**Proof of Evidence for Covent Garden Community Association
re problems with Servicing requirements of the development
and issues related to the Draft Construction Management Plan**

Document ref. no. 2.1a

Appeal References: APP/X5210/W/19/3243781 & APP/X5210/Y/19/3243782.

Site: Odeon Cinema, 135-149 Shaftesbury Avenue, London WC2H 8AH.

Figure 6: Proposed Highway Arrangement – New Compton Street

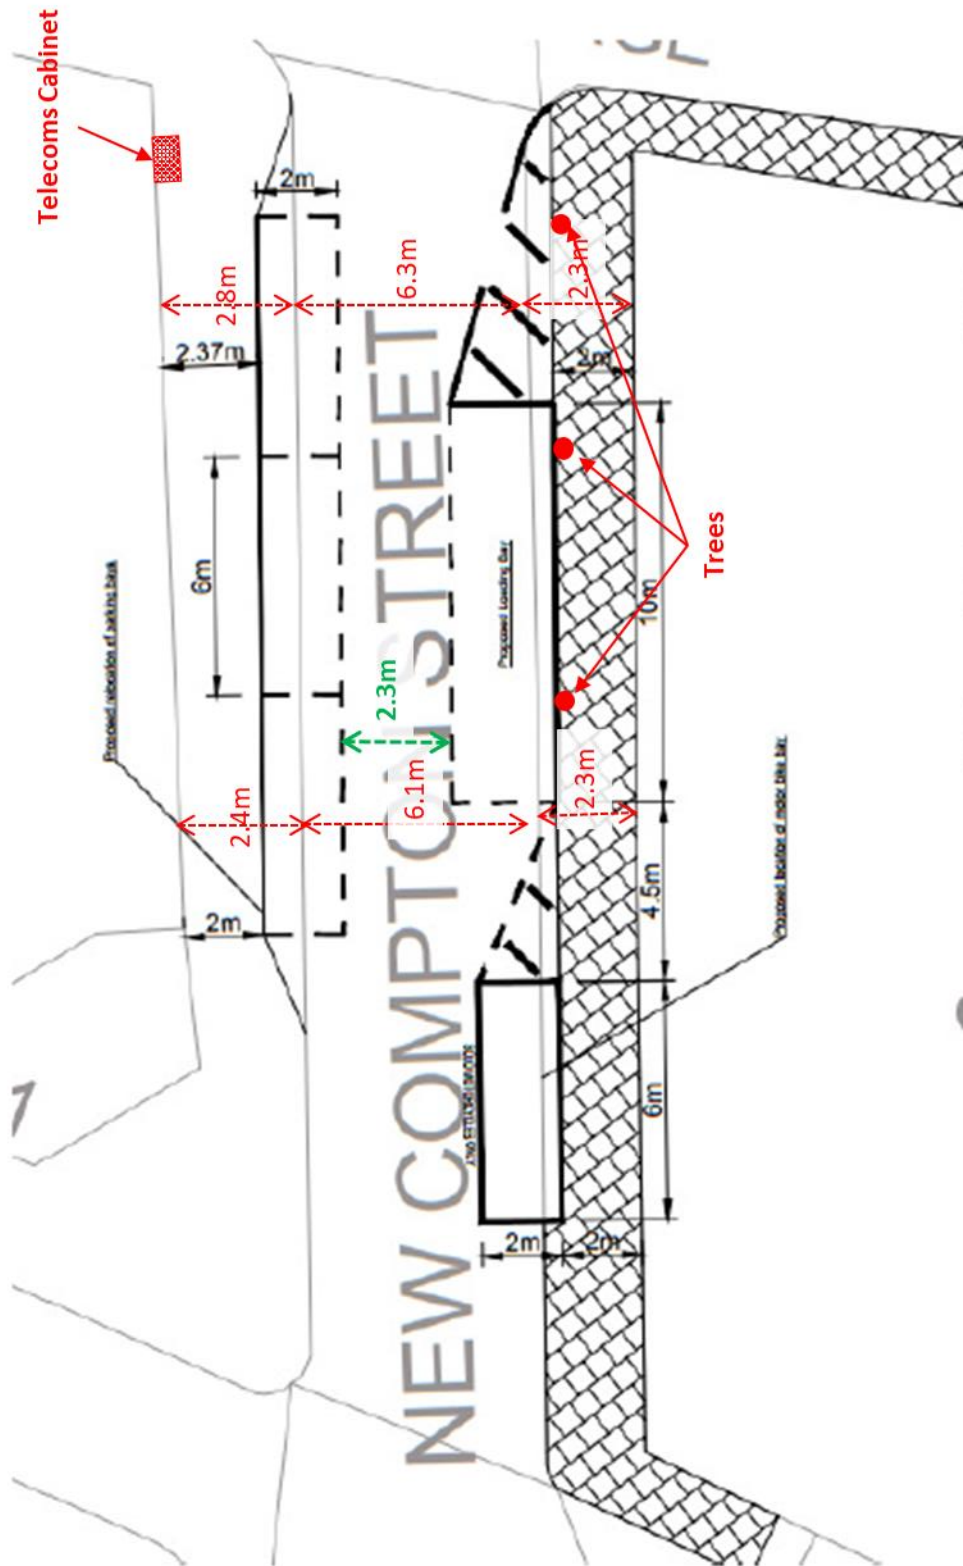
4.3. To make space for this bay the footway on both sides of the street will be narrowed to 2m and the existing residents bays will be moved to the North side of New Compton Street which requires 3 existing residents bays to be moved to the opposite side of the street. This is shown in Figure 6 of the Delivery and Servicing Plan and in section A2.

4.4. The widths of the proposed pavements and the residents bay are shown but the width of the loading bay and the available kerb to kerb distance have not been marked. It is therefore not possible from the drawings to determine the available width for vehicles to pass when the residents bays and loading bays are both occupied.

4.5. I have measured and calculated the available width at the West and East end of the proposed loading bay. The calculation is shown at Appendix 5, and a drawing of the area at Appendix 6. On the basis of this calculation I have concluded that at the West End of the proposed loading bay there will only be 2.3m of available road width. This is not sufficient for a vehicle larger than a light goods vehicle to pass this point. Even smaller vehicles are likely to slow to pass and may manoeuvre in low gear. This increases noise and reduces air quality.

4.6. The drawings provided regarding the road layout omit 3 trees which would need to be removed to narrow the pavement. There is no mention of this in the application.

4.7. The loading bay and road layout proposed are not suitable and will result in noise, traffic and pollution associated with the servicing of the development.
